UNITED STATES PATENT AND TRADEMARK OFFICE

APPLICATION NO.	FILING DATE	FIRST NAMED INVENTOR	ATTORNEY DOCKET NO.	CONFIRMATION NO.
09/748,277	12/27/2000	Jae-Lag Ma	8733.363.00	4729

<b>Office Action Summary</b>	Application No. 09/748,277	Applicant(s) MA ET AL.	
	Examiner Timothy L Rude	Art Unit 2883

Fig. 1

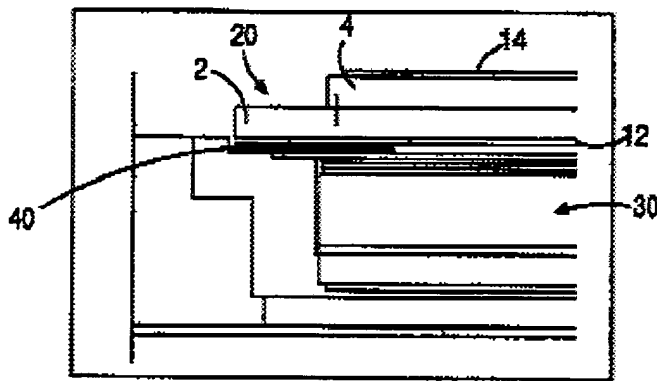
As to claims 6 and 9-12, APA discloses in Figures 1-4 (Specification pages 2-4), a dot matrix (Specification, Page 2, lines 18-22) liquid crystal display (LCD) device, comprising:

an upper polarizer, 14; on an upper substrate, 4;

a lower substrate, 4, on a lower polarizer, 12;

a liquid crystal layer (not shown) disposed between the upper substrate and the lower substrate; and

a backlight device, 30, disposed opposite and adjacent to the lower polarizer for emitting light toward the lower polarizer (Figure 1) (please note that adjacent does not preclude structures between those items considered to be adjacent, e.g., two houses may be adjacent despite the existence of an intervening garage);

wherein at least a black pad, 40, that acts as a light shield (Applicant's light shielding film) formed in a rectangular shape only along a peripheral portion (evident from Specification, Page 3, lines 11-14); and

wherein the light shielding film absorbs light (property of the color black).

APA does not explicitly disclose a lower polarizer that includes said light shielding film.
